21st October 2022

Development Application No. DA2022/1000
Issues response/ Supplementary Statement of Environmental Effects
Demolition works, alterations and additions to existing buildings and
construction of new mixed-use buildings
Royal Far West
19 - 21 South Styene and 22 Wentworth Street, Manly

Figure 1 - Plan extract showing the overall spatial relationship and juxtaposition of the proposed development to the residential flat building at No. 29 Victoria Parade

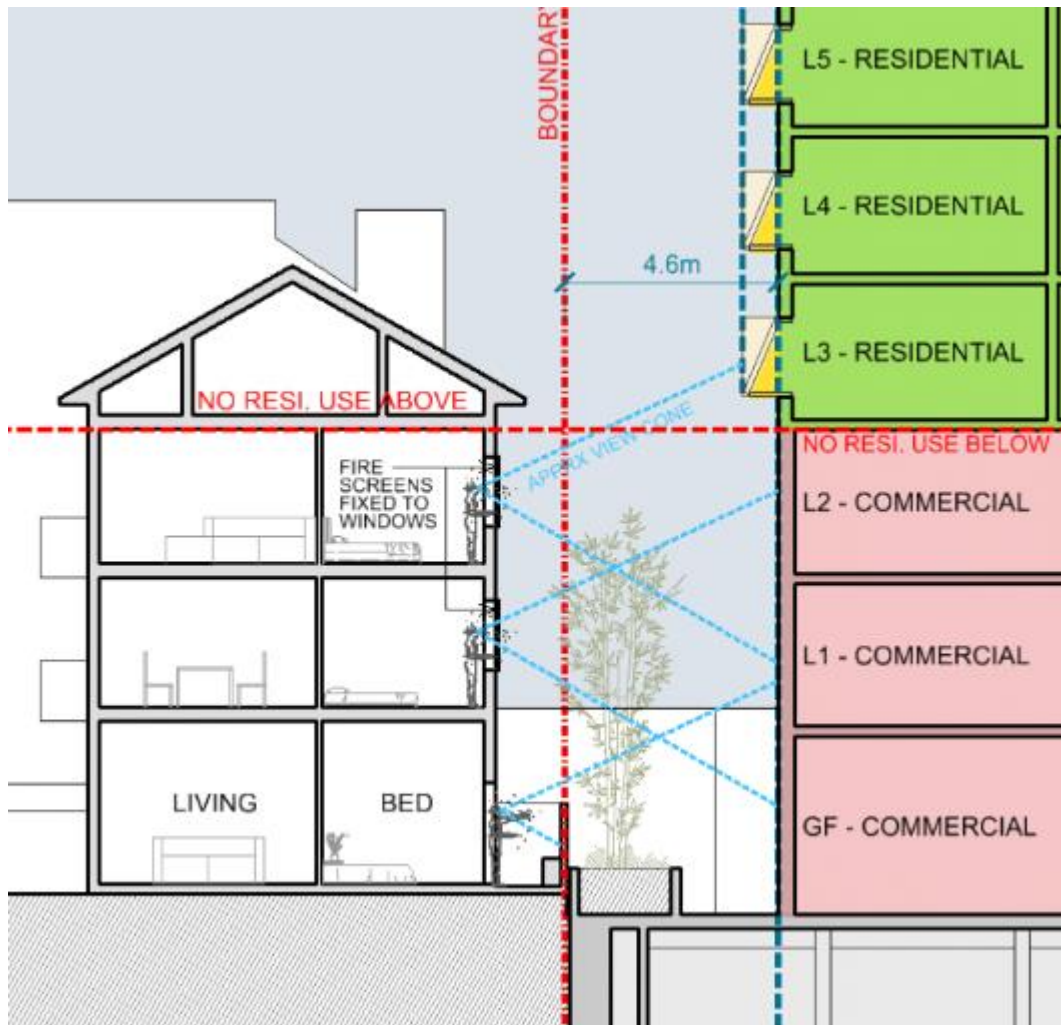
2. Concept Approval – Condition B1 Building Envelope and Separation (Building C)

Consideration must also be given to the overall spatial relationship and juxtaposition of proposed Building C to the residential flat building at No. 29 Victoria Parade whereby the portion of the proposed building located immediately adjacent, in a horizontal plane, to the residential apartments within the adjoining building are the ground, Level 1 and Level 2 floors which are to be occupied by the proposed commercial tenancies.

- The amended plans provide a 4.6 metre setback where the residential apartments at No. 29 Victoria Parade immediately adjoining the proposed commercial floor plates as depicted in Figure 1 below.

- The proposed 4.6 metre setback facilitates adequate soil planting zones and associated plantings as depicted on the accompanying landscape plans to visually screen the commercial tenancies as viewed from the adjoining residential apartments. Such outcome not only satisfies the numerical requirement but also its stated objective/purpose being the establishment of landscaping to visually screen the commercial tenancies.

- The proposed 4.6 metre setback at ground level, Level 1 and Level 2 is in strict accordance with the setback requirement with integrated privacy measures incorporated into the west facing fenestration at these levels to optimise/ maintain appropriate residential amenity in relation to privacy.

- The building façade associated with the residential floor plates located above the eave line of the adjoining residential flat building at No. 29 Victoria Parade also maintains a 4.6 metre setback to the common boundary although bay windows with integrated privacy and sun shade louvres do project within the 4.6 metre setback by up to 700mm.
